Proposal for Supplement 11 to the 01 Series of Amendments to UN Regulation No. 43 (Safety glazing)

The text reproduced below was prepared by the expert from the Republic of Korea, which is based on the paragraph 10. of the minutes of 124th GRSG session (ECE-TRANS-WP.29-GRSG-103). And it supersedes the working document (ECE-TRANS-WP.29-GRSG-2023-07) that has already been submitted since it needs to be corrected some errors. The modifications to the text of the working document are displayed in red. (Marked in bold for new and strikethrough for deleted characters)

Figure 22

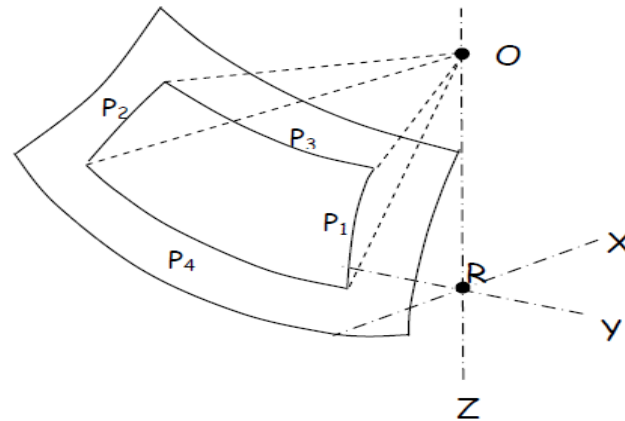
Paragraph 9.2.5.2.3, amend to read and insert a new figure 22:

"9.2.5.2.3. Zone I is the windscreen zone determined by the intersection of the windscreen with the four planes defined below:

In addition, opaque obscuration can be exempted in Zone I. It is the limited areas where it is intended that a sensing device, e.g. a rain-drop detector, rear view mirror or autonomous sensors, will be bonded to the inner side of the windscreen. The opaque obscuration where such devices may be applied is defined in paragraph 9.2.5.2.4. of this Annex.

P1 – A vertical plane passing through 0 and forming an angle of 15° to the left of the median longitudinal plane of the vehicle;

P2 – A vertical plane symmetrical to P1 about the median longitudinal plane of the vehicle.

If this is not possible (in the absence of a symmetrical median longitudinal plane, for instance) P2 shall be the plane symmetrical to P1 about the longitudinal plane of the vehicle passing through Point 0.

P3 – A plane passing through the straight Line OQ and forming an angle of 10° above the horizontal plane;

P4 – A plane passing through the straight Line OQ and forming an angle of 8° below the horizontal plane.

Figure 23

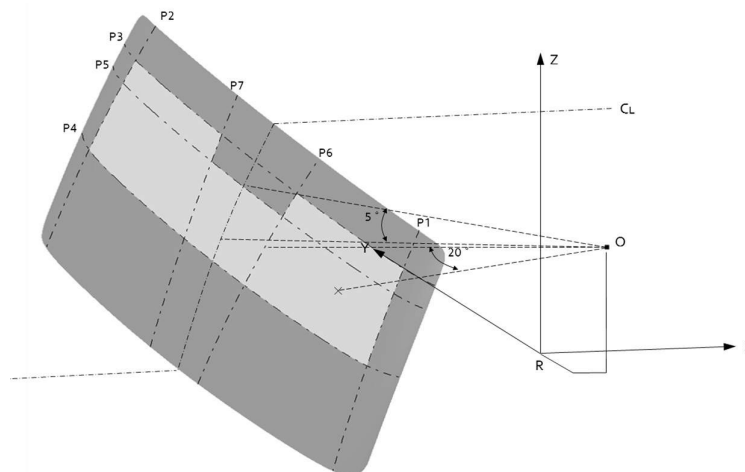
Insert new paragraphs 9.2.5.2.4., to 9.2.5.2.4.1., amend to read and insert a new Figure 23:

9.2.5.2.4. Determination of the opaque obscuration

P5 – a plane passing through a transverse horizontal line containing O and forming an angle of 5° above the horizontal plane

P6 – a vertical plane passing through O and inclined at 20° to the right of the X axis in the case of left-hand drive vehicles and to the left of the X axis in the case of right-hand drive vehicles.

P7 – a plane symmetrical to P6 in relation to the longitudinal median plane of the vehicles.

9.2.5.2.4.1. Any opaque obscuration bounded downwards by P5 and laterally by P6 and P7. (See figure 23)

(Upper obscuration area as defined in paragraph 9.2.5.2.4.1.)
